PIKE

601 EAST PIKE STREET

CITY OF SEATTLE DESIGN REVIEW

RECOMMENDATION
DPD PROJECT #3021639
DECEMBER 16, 2015

STREET LEVEL FACADE ALONG E. PIKE STREET

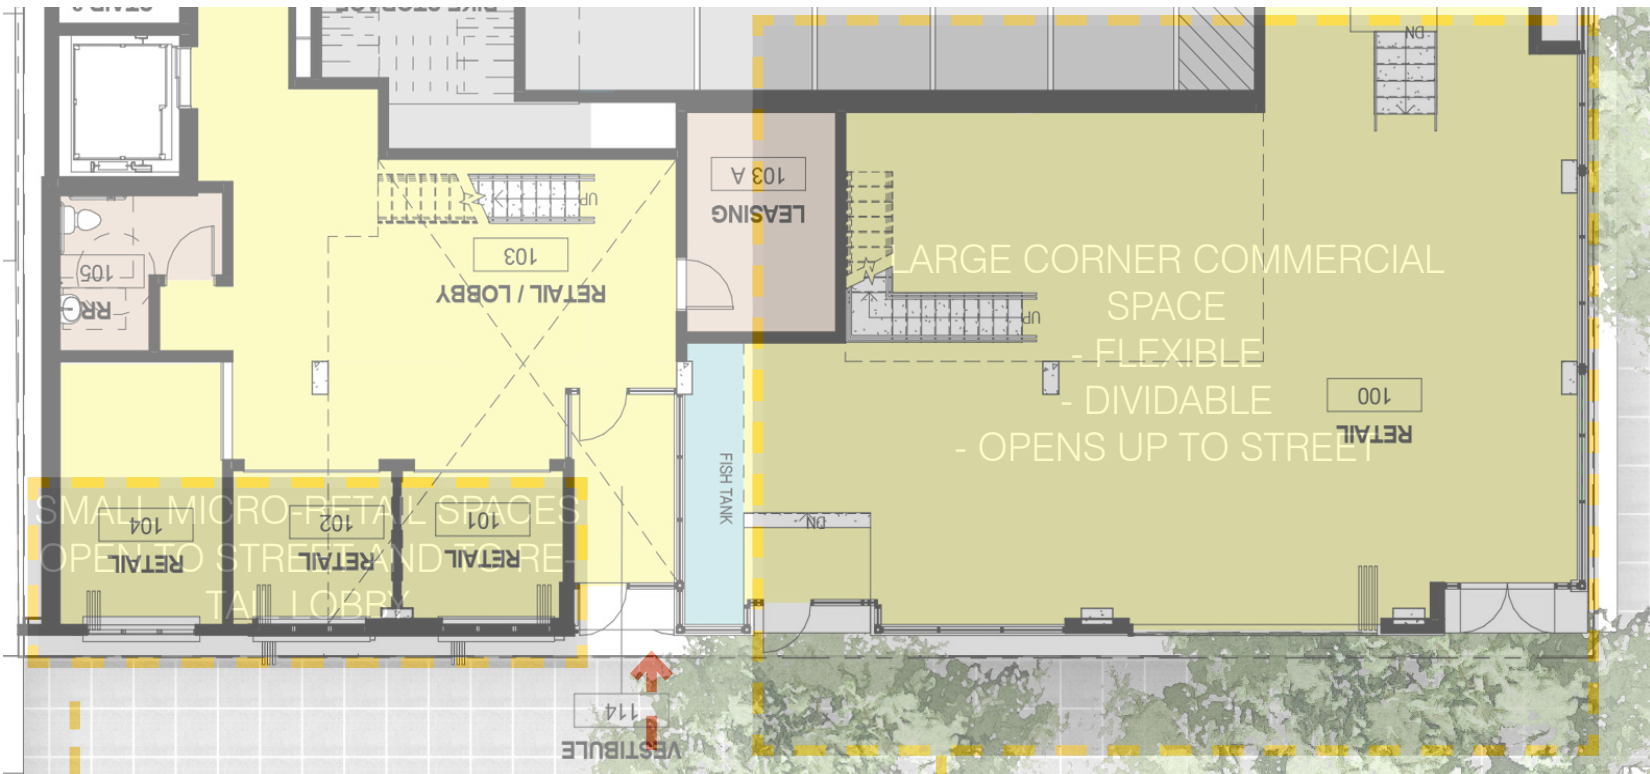
DRB RECOMMENDATION - STREET LEVEL SPACES

(Design Guidelines: CS2-B2; PL2-B3, C3; PL3-A1b, A1C, C1; DC1-B1, C4; DC2-D1, D2)

"The street level spaces should be designed to maximize human activity and human scale."

- The Board noted that all the street level spaces should be designed to provide human scale for pedestrians.
- The Board was troubled by the Belmont street frontage, which appeared to lack active retail or lobby entries, and instead was dominated by the parking garage entry and a solid waste storage area.

- The proposed program should be reconfigured to enhance human activity on Belmont Ave. The Board noted that possible solutions include incorporating the stairs inside the building and extending the retail frontage further up Belmont, locating the lobby on Belmont Ave, and moving the solid waste storage into the building to allow the parking entry to shift to the south to make room for retail or lobby street frontage.

- The Board discussed the lobby location, and agreed that as long as it is placed to maximize contiguous retail frontage, then it's acceptable at either the Belmont Ave or E. Pike St. frontages.

- The Board agreed that the general location of the parking access near the southwest corner is the best option. The Board would be supportive of departures to minimize the visual and physical impacts of the parking entry on the pedestrian environment.

RESPONSE

In response to the Board's recommendations regarding Street Level Spaces, the following has been done:

- The retail glazing is extended around the corner on Belmont Avenue.**
- Generous street level landscaping, as well as a green wall and decorative gate have been added on Belmont Avenue.**
- A large fish tank at the building's main entry engages passersby and creates a connection between the lobby and the main retail space.**
- Glazing on Pike Street is about 50% operable, allowing retail activities to engage with the sidewalk.**
- Unique vegetated canopies provide weather protection to pedestrians.**
- The residential lobby is fully integrated with micro retail spaces that open onto the sidewalk and provide opportunities for unique small businesses.**

VIEW FROM SOUTHWEST

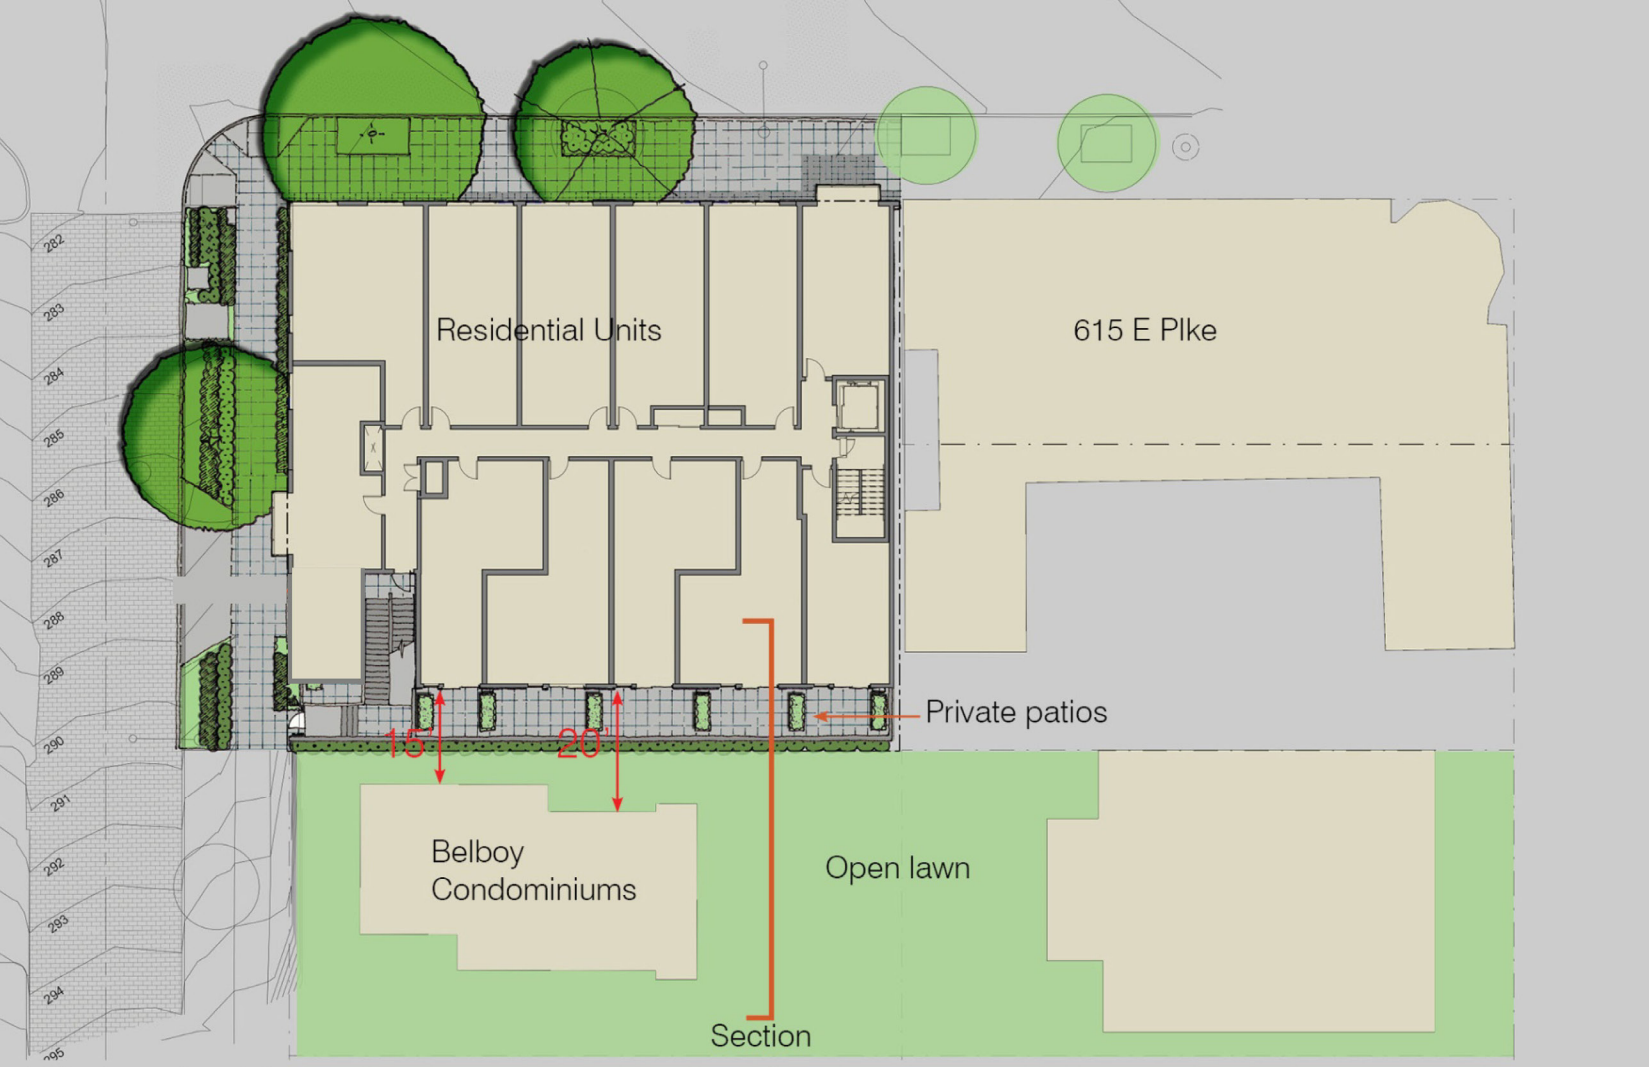
DRB RECOMMENDATION - RELATIONSHIP TO PROPERTY TO THE SOUTH

(Design Guidelines: CS2-D4, D5; CS3-A1; DC2-A2)

"The proposed development should maintain at least the proposed 10' setback from the adjacent site to the south."

- The Board noted that the possible solutions to the Belmont Ave. street frontage might affect the building massing. The Board clarified that the 10' setback from the south property line is strongly preferable, in order to maximize light and air to the much smaller residential buildings and open space to the south.
- The Board suggested an upper level setback on the south facade may help to reduce the appearance of bulk and scale to the south.

RESPONSE

In response to the Board's recommendations regarding Relationship to Property to the South, the following has been done:

- A 10' setback from the south property line has been maintained.
- Solar awnings have been added to the south facade which will provide partial screening to the property to the south from the upper floors of the building.
- A vegetation-covered trellis has been added at the south property line to maintain the privacy of the property to the south.

A 10' building setback at the residential levels helps to maximize light and air to the adjacent property.

Solar awnings produce electricity, provide shading for southern facing windows, and help to screen views to the adjacent property from upper levels.

Patios at level three terrace are screened by a vegetation-covered trellis to maintain privacy of the adjacent property.

1. SIGHT TRIANGLE (SMC 23.54.0303.G.1)

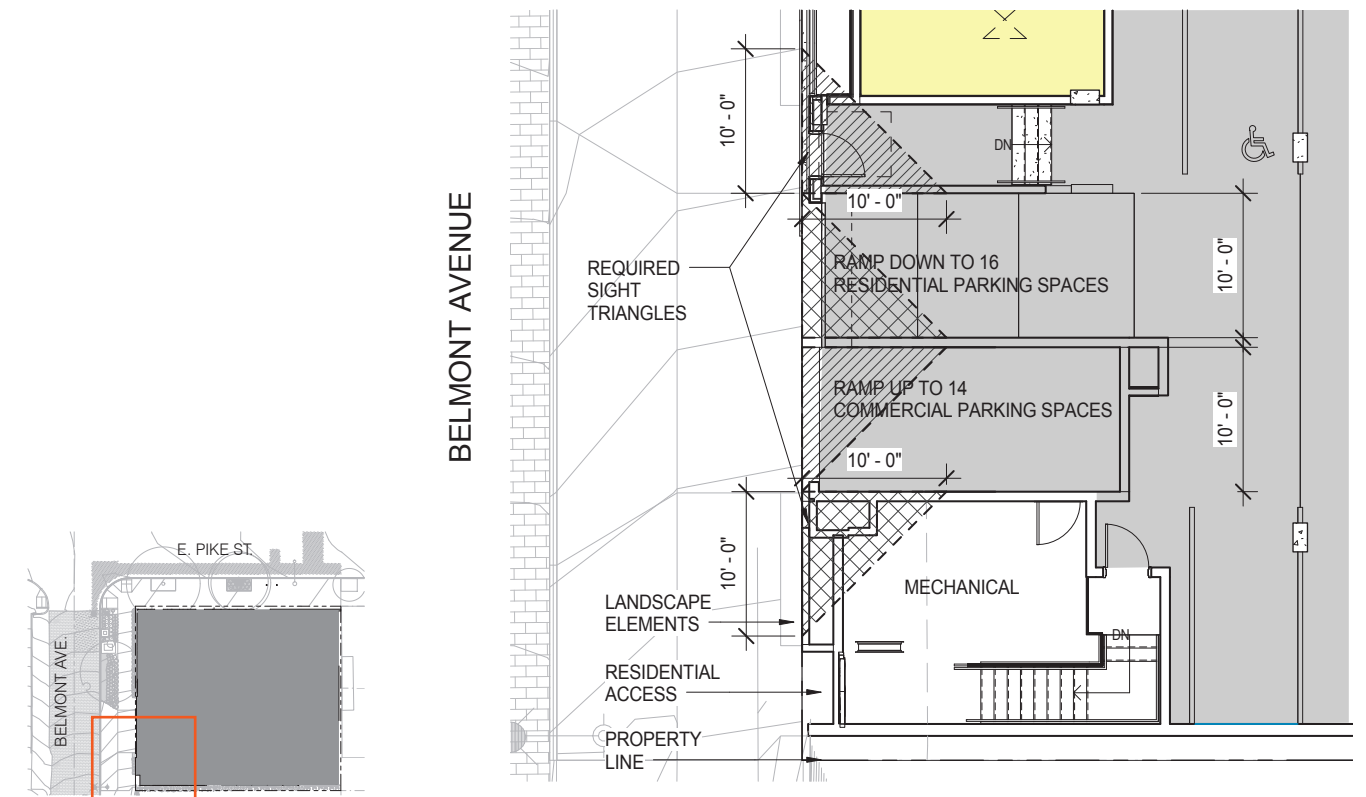
Code Requirement

SIGHT TRIANGLE (SMC 23.54.0303.G.1): A sight triangle is required on either side of a two-way driveway less than 22 feet wide.

Departure Requested

The applicant proposes to provide mirrors or other safety measures instead of the sight triangles.

Eliminating the sight triangles minimizes the appearance of the driveways, which would otherwise dominate the street-level facade on Belmont Avenue. Planted areas are proposed directly adjacent to the building in order to move the sidewalk away from the face of the building. All parking will be monthly rental in order to reduce in-and-out traffic.

2. STREET-LEVEL DEVELOPMENT STANDARDS (SMC 23.47A.008.B)

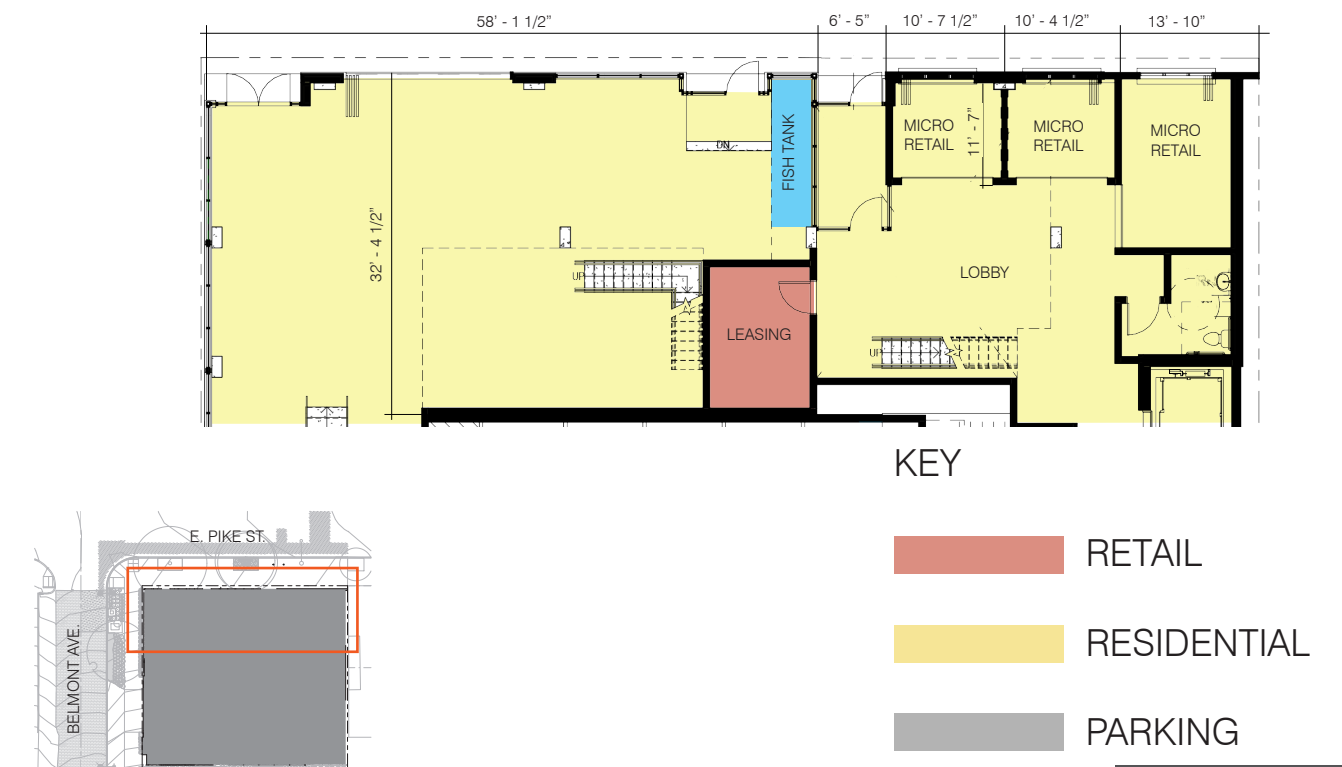
Code Requirement

STREET-LEVEL DEVELOPMENT STANDARDS (SMC 23.47A.008.B): Nonresidential uses at street level shall have an average depth of 30' and a minimum depth of 15'.

Departure Requested

The applicant proposes an average depth of 26'-6" and a minimum depth of 11'-7".

The ground floor design includes a market-style lobby that will feature several small shops that can open to the street and to the main lobby. Art installations and a floor-to-ceiling living wall on the interior will create a dynamic hybrid of retail and lobby functions.

3. STREET LEVEL DEVELOPMENT STANDARDS (SMC 23.47A.008.B.4)

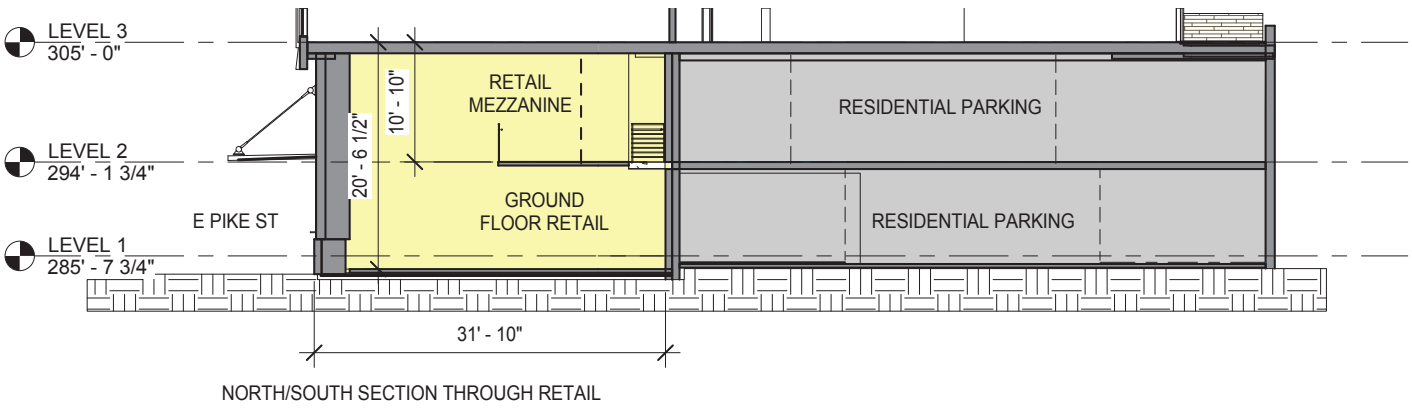
Code Requirement

STREET LEVEL DEVELOPMENT STANDARDS (SMC 23.47A.008.B.4): Nonresidential uses at street level shall have a floor-to-floor height of at least 13 feet.

Departure Requested

The applicant proposes to provide retail mezzanines with a minimum 9 foot floor-to-floor-height.

The overall floor-to-floor height of the spaces is a minimum of 19'-10", a height that provides the opportunity for mezzanines like those found in other buildings in the neighborhood, such as the 615 E Pike building and the Pineway. Combined with the generous transparency at the perimeter, the mezzanines help create dynamic retail spaces. See diagram 1 / G005

4. STREET LEVEL USES (SMC 23.73.008.C)

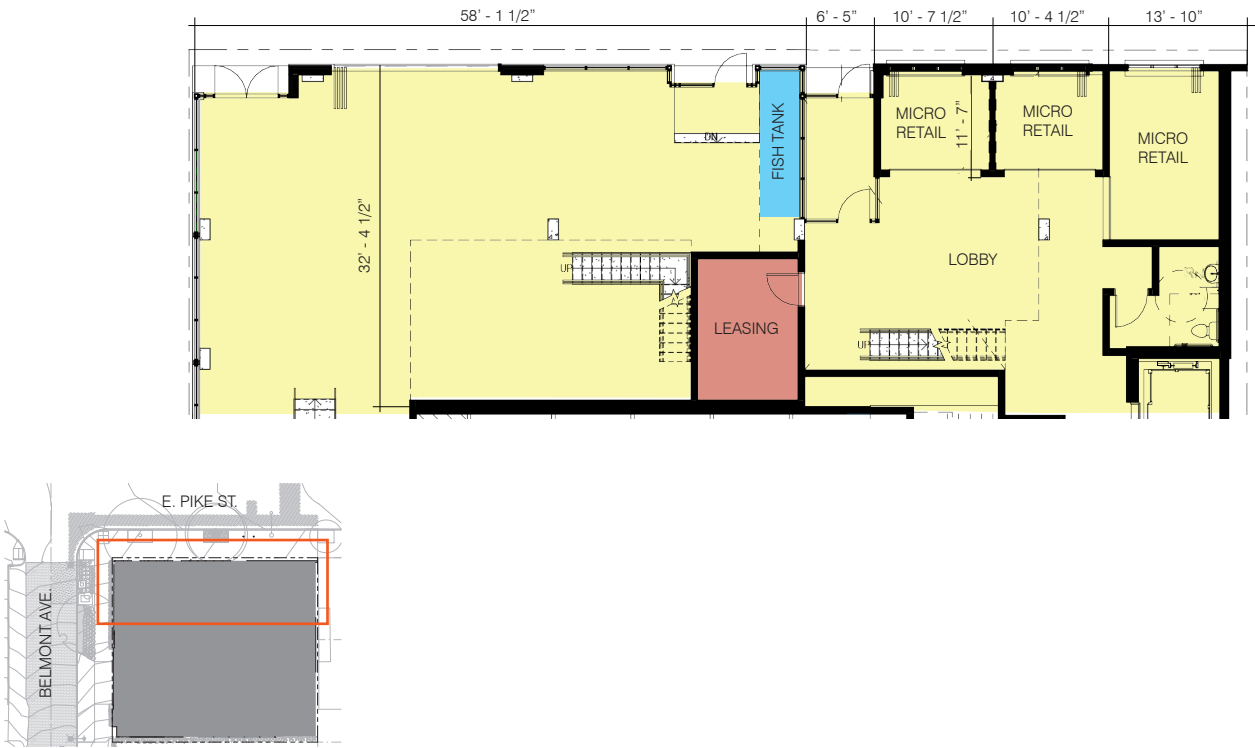
Code Requirement

STREET LEVEL USES (SMC 23.73.008.C): Within new structures that face Pike, East Pike, Pine, and East Pine streets, the length of street frontage permitted at street level for an individual business is limited to 50 feet.

Departure Requested

The applicant proposes to provide a length of 58' 3" for the longest individual business street frontage.

The project provides multiple entrances and setbacks for this larger retail space, as well as micro-retail spaces in the adjacent street frontage retail area, to help maximize the sense of multiple street-facing businesses.

5. DEMOLITION OF CHARACTER STRUCTURE ON SITE RECEIVING TDP (23.73.024.B.1.b)

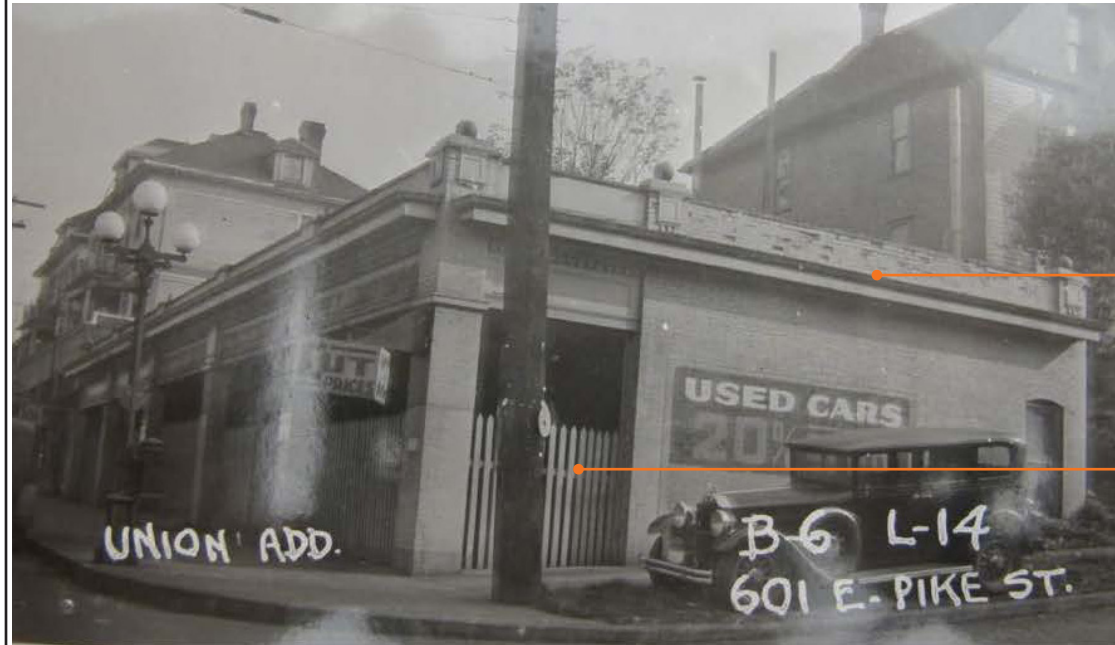
The existing one-story concrete and brick structure was built in 1908 and qualifies as a character structure per SMC 23.84A.006. It is not listed in Director's Rule 3-2012 as a building that must be retained. Over time the exterior has been altered drastically so that almost none of its original character remains. The interior has low ceiling heights and a very utilitarian structure. The project team has concluded that the design intent could be achieved better with new construction than by retaining the existing structure.
